UNITED STATES
DEPARTMENT OF THE INTERIOR
BUREAU OF LAND MANAGEMENT

SUNDRY NOTICES AND REPORTS ON WELLS 2019
Do not use this form for proposals to drill or to re-enter an abandoned well. Use form 3160-3 (APD) for such proposals.

Leontodon ASH Federal Com #1

Leontodon Ash Federal Com 1
30-005-63324
EOG Y RESOURCES, INC.
May 28, 2019
Conditions of Approval

Leontodon ASH Federal Com #1

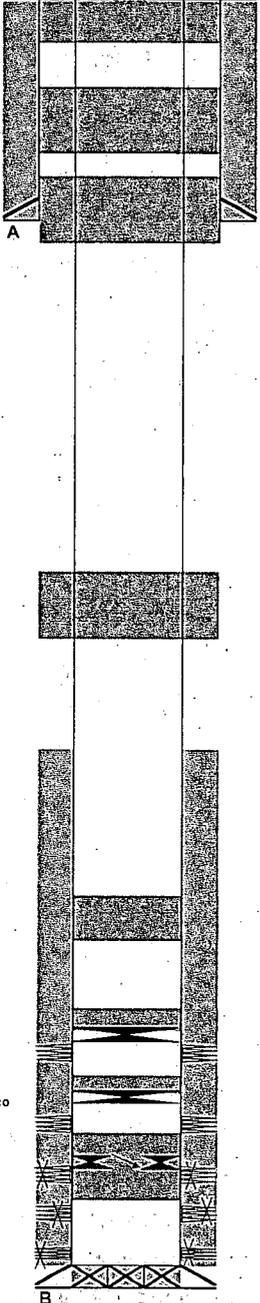
1. Operator shall place CIBP at 5,965' (50'-100' above top most perf) and place 30 sx of Class C cement on top as proposed by operator. WOC and TAG.
2. Operator shall place CIBP at 5,430' (50'-100' above top most perf) and place 37 sx of Class C cement on top as proposed to seal the top of the Wolfcamp. WOC and TAG. Tag no less than 5070' to seal the top of the Wolfcamp Formation

3. Operator shall place a balanced Class C cement plug from 4,500'-4,250' as proposed to seal the Abo Formation.
4. Operator shall perf at 2,200' and squeeze 35 sx as proposed. Operator shall place a balanced Class C cement plug from 2,200'-2,070' as proposed to seal the Glorettia Formation.

5. Operator shall perf and squeeze at 1,200'. Operator shall place a balanced Class C cement plug from 1,200'-1,080' to seal the 8-5/8" shoe as proposed. WOC and TAG.

6. Operator shall perf and squeeze at 1,050'. Operator shall place a balanced Class C cement plug from 1,050'-930' as proposed. WOC and TAG.
7. Operator shall perf and squeeze at 100'. Operator shall place a balanced Class C cement plug from 100' to surface.
